UNITED STATES
NUCLEAR REGULATORY COMMISSION
WASHINGTON, D. C. 20555

SUBJECT: DAVIS-BESSE---STEAM AND FEEDWATER RUPTURE CONTROL SYSTEM

Reference: NRC memorandum, Thompson to Denton, "Preliminary
Review of the Design and Performance of the Davis-Besse
Feedwater and Related Systems", July 2, 1985

CONTROL SCHEME FOR VALVE MS-107
(MAIN STH ISO VALVE TO APT M2)

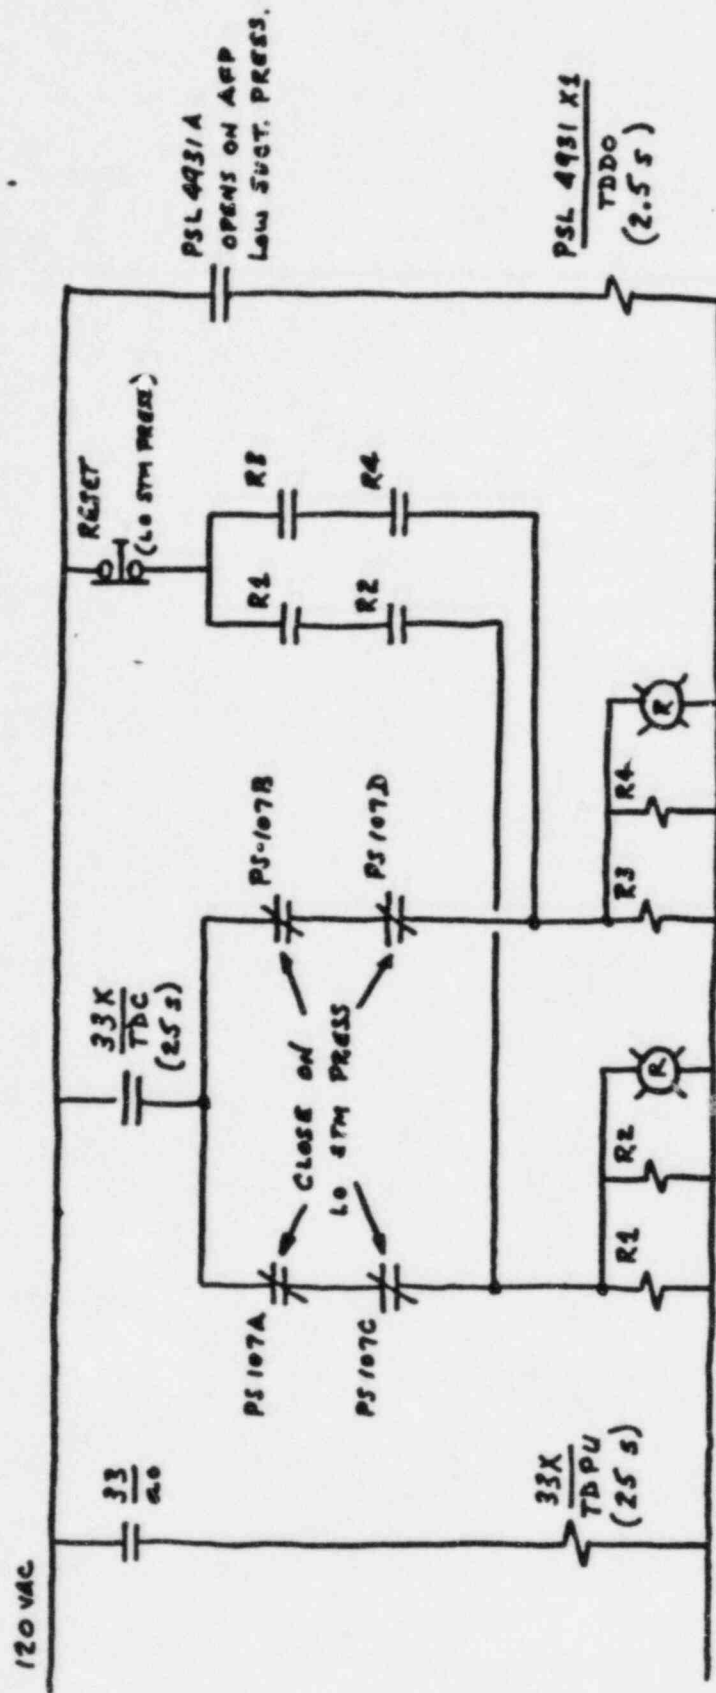
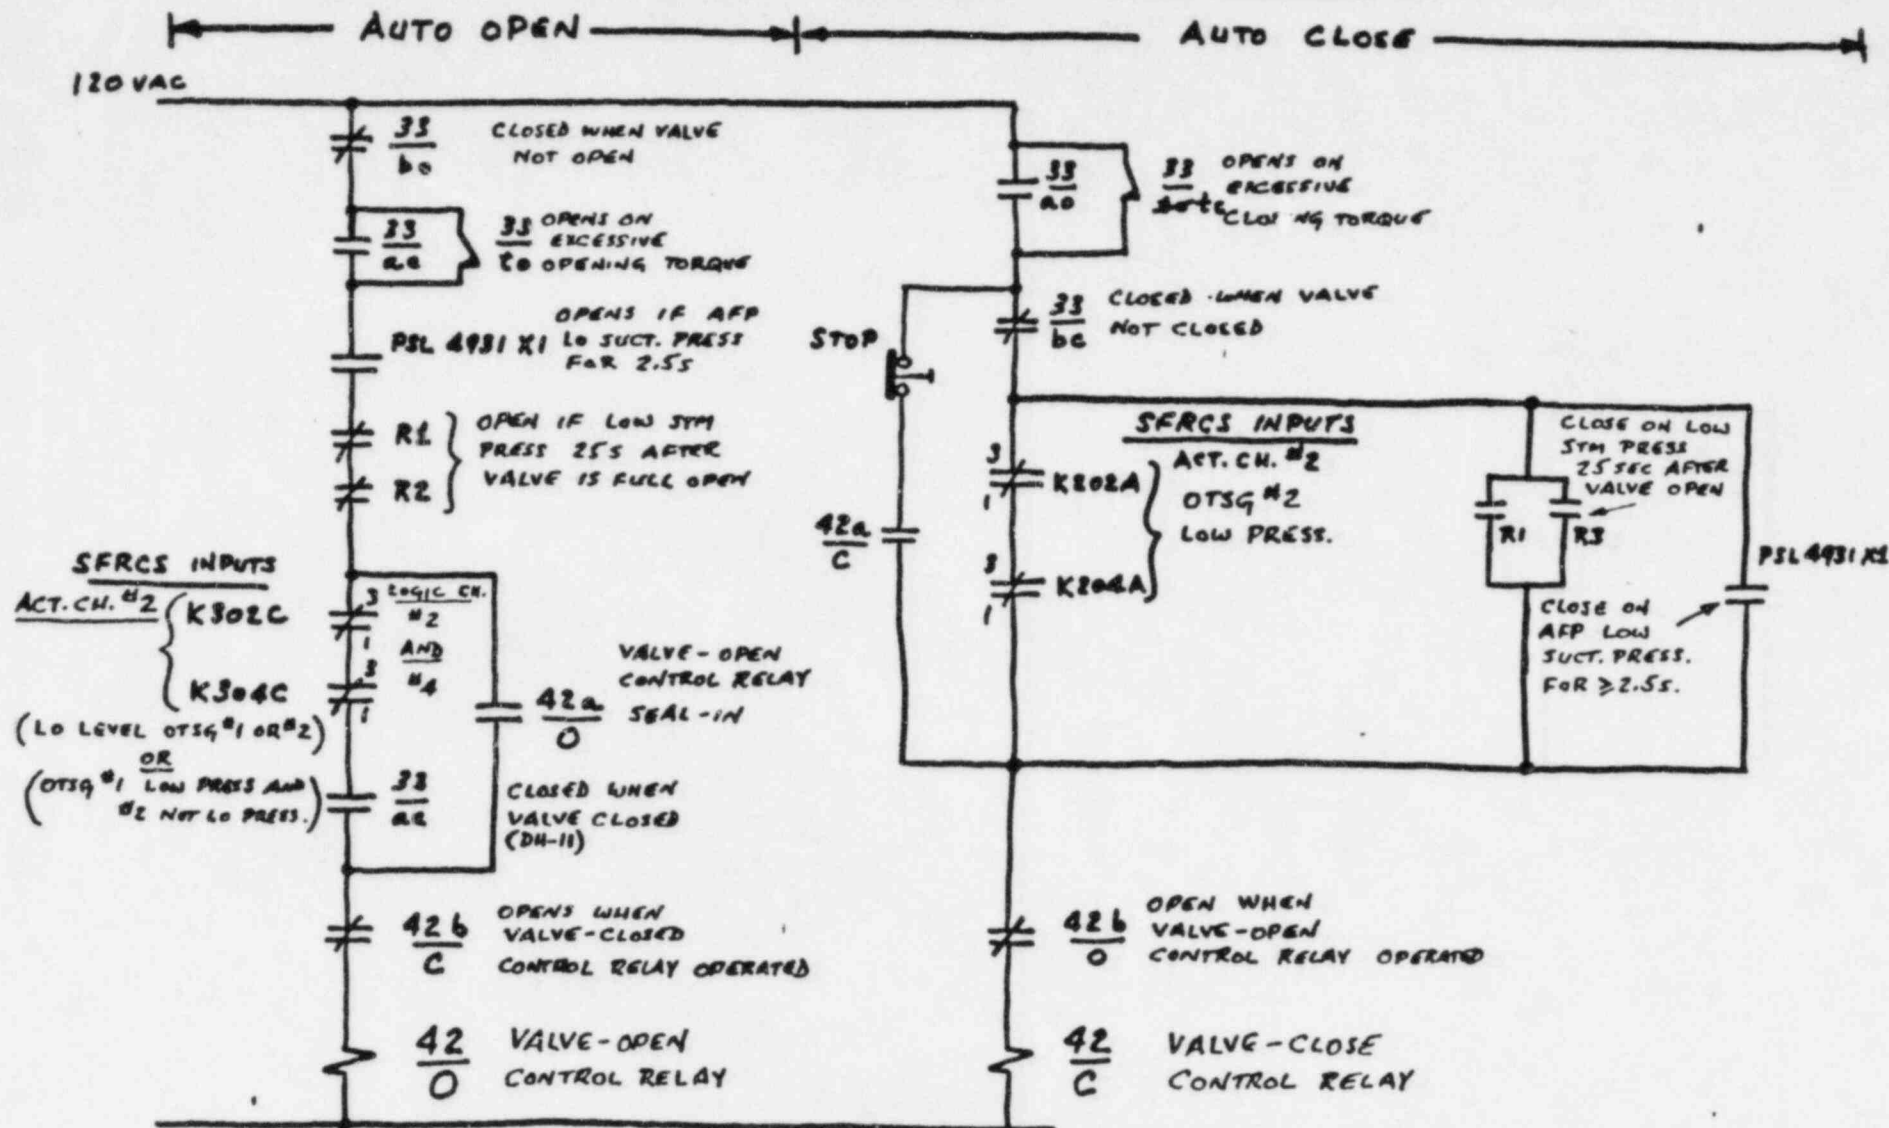
6.3.2.6 The SFRCS is designed for automatic reset as soon as the plant variable returns to within the trip setpoint value. The review of the control scheme for the actuated equipment (e.g. MS-107) indicates that, if the reactor operator (willfully or inadvertantly) uses the normal controls to request that the actuated equipment go to the non-safety state (e.g. close MS-107 after it has opened), the equipment will in fact go to the non-safety state (e.g. MS-107 will close), whether the SFRCS actuation signal is still present or has reset itself. Paragraph 7.4.2.3.1 of the USAR states that: "The actuated Class 1E equipment once initiated by the SFRCS will remain in its actuated stated until deliberately and individually reset by operator action." This type of statement normally refers to a separate reset action to be taken to make the normal controls available for operator use (i.e. a two-step process is provided to position the equipment out of its safety-state). The SFRCS-actuated equipment does not appear to have inhibit features that would preclude re-positioning until the reset is operated. The significance of this apparent discrepancy has not be evaluated.
